**EMERGENCY MANAGEMENT PLAN
FOR
MATAGORDA COUNTY, BAY CITY, AND PALACIOS
ANNEX W PROCEDURES
FIXED NUCLEAR FACILITIES RESPONSE**

**RADIOLOGICAL EMERGENCY PREPAREDNESS (REP) PLAN
(SOUTH TEXAS PROJECT ELECTRIC GENERATING STATION)**

Distribution Transmittal/Acknowledgement

**SUMMARY OF CHANGES FOR THE EMERGENCY MANAGEMENT PLAN
(Annex W) RADIOLOGICAL EMERGENCY PLAN (REP) PROCEDURES FOR Rev 8
MATAGORDA COUNTY, BAY CITY AND PALACIOS**

**EOC FLOOR PLAN
Attachment 2
(Page 1 of 2)**

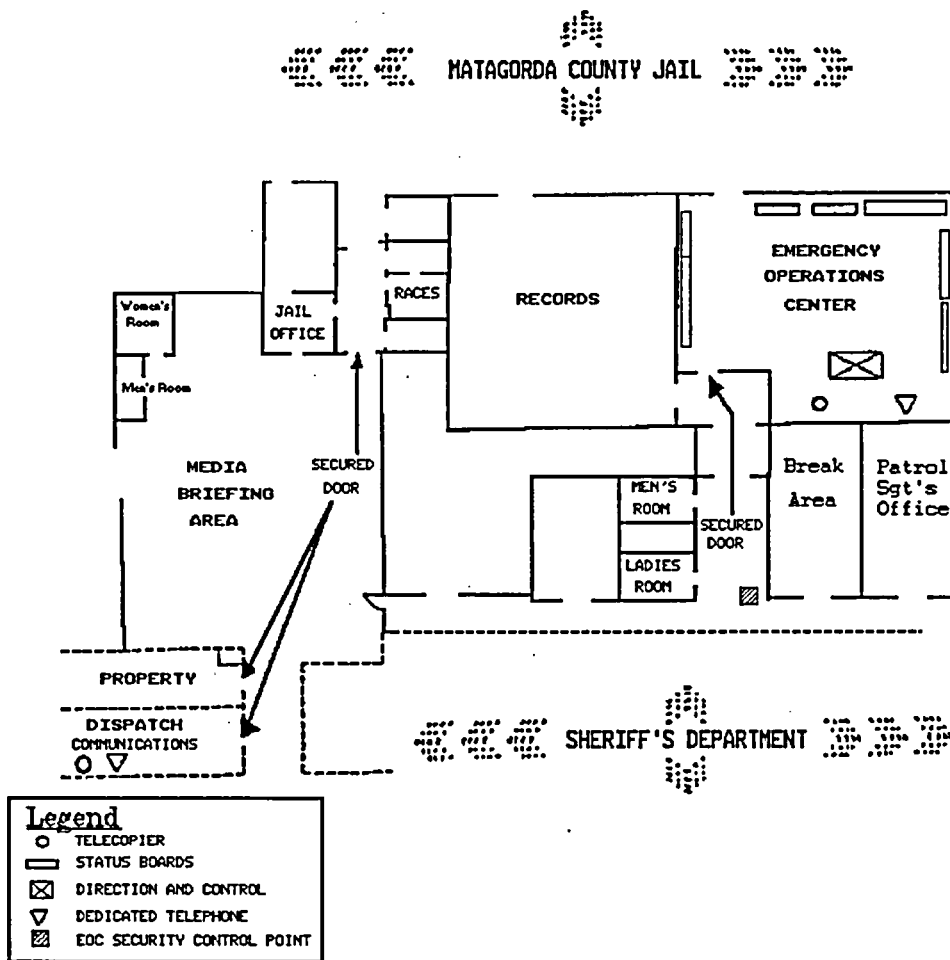
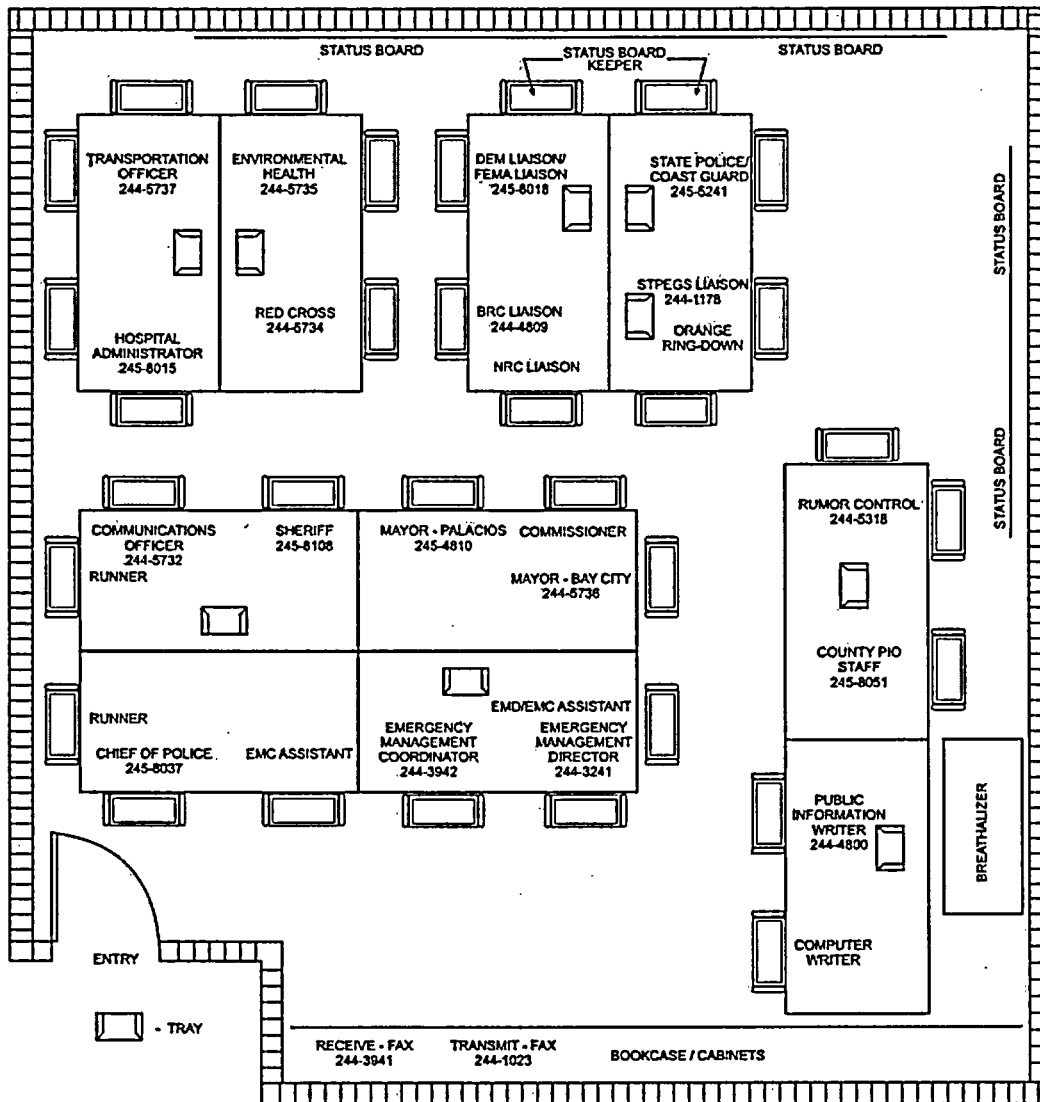
| PROCEDURE NUMBER/ REVISION NUMBER | CHANGE NUMBER | DESCRIPTION OF PROCEDURAL CHANGE (Provide general verbal description of change (reference paragraph, attachment number, page number, etc., as necessary.) | REASON FOR CHANGE (Administrative, Procedural Change, Procedural Enhancement, Regulatory (e.g., ARCA, FEMA Recommendations, etc.), New Criteria, Other) |
|--|--------------------------|---|---|
| 13/6 | 1. | Updated the Emergency Operations Center (EOC) floor plan. | Changed floor plan to reflect updates to the seating locations and phone line set-ups. |
